**RAYMOND C. VAUGHAN, PH.D., P.G.**  
Professional Geologist / Environmental Scientist  
534 Delaware Ave., Suite 302, Buffalo, NY 14202  
(716) 332-7113 • rcvaughan9@gmail.com

From: Raymond C. Vaughan, Ph.D., P.G.  
To: Sierra Club Atlantic Chapter  
Subject: Hakes FSEIS does not rebut the evidence presented by Sierra Club  
Date: February 21, 2019

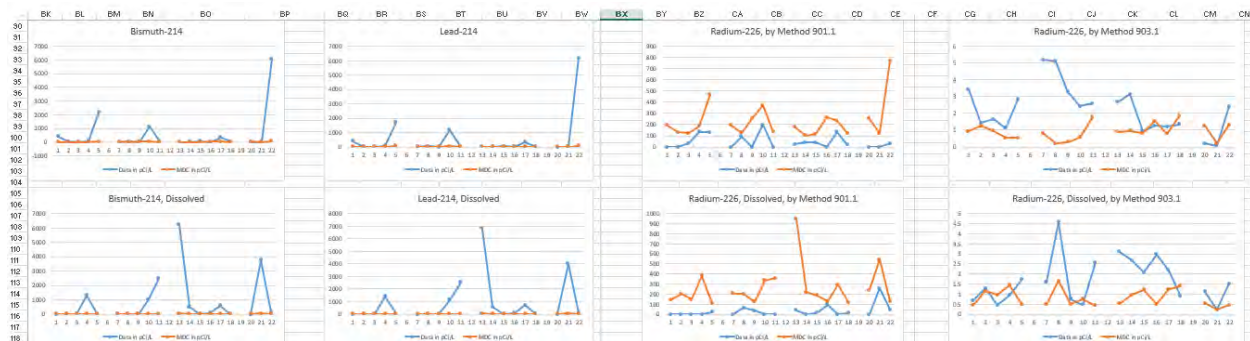
The following figures from my January 18, 2018 affidavit show the intermittently high levels of Lead-214 and Bismuth-214 in the leachate, ranging up to ~6000 pCi/L, and the substantially lower levels of Radium-226 in the leachate, as reported in the semiannual test results for these three radionuclides.<sup>2</sup> Similar results, ranging up to ~1000 pCi/L, are shown by the data from the Chemung County landfill leachate tests. These results are included here because they illustrate that another landfill that has taken high levels of drill cuttings and other gas drilling wastes also manifests intermittently high levels of Lead-214 and Bismuth-214 in leachate.

Results from the Hakes and Chemung County leachate test reports are plotted below, where the horizontal axis on each graph is time, and the graphs show four different time trends. The blue

In summary, the above graphs show that the test results (blue lines) for Bismuth-214 and Lead-214 are intermittently very high, ranging up to about 6000 pCi/L in Hakes leachate and 1000 pCi/L in Chemung leachate, while the test results (blue lines) for radium in Hakes and Chemung leachate remain much lower.

### For Chemung County Landfill:

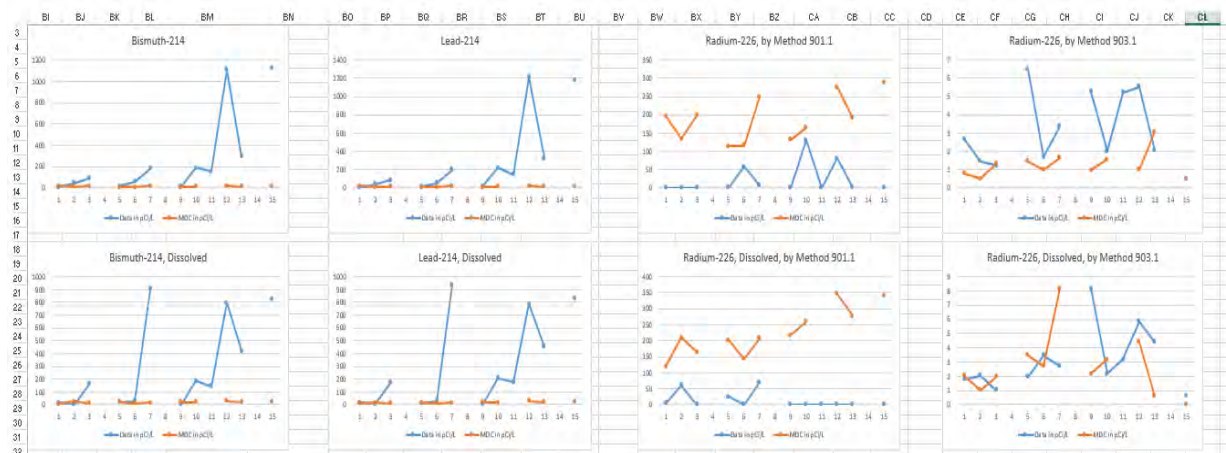
- 1-3 are the 2015-2017 time trend for Leachate Pond (Combined Leachate)
- 5-7 are the 2015-2017 time trend for Cells I through III Primary Leachate
- 9-13 are the 2015-2017 time trend for Cell IV Primary Leachate
- 15 is the single data point for the 2017 measurement of Cell V Primary Leachate.
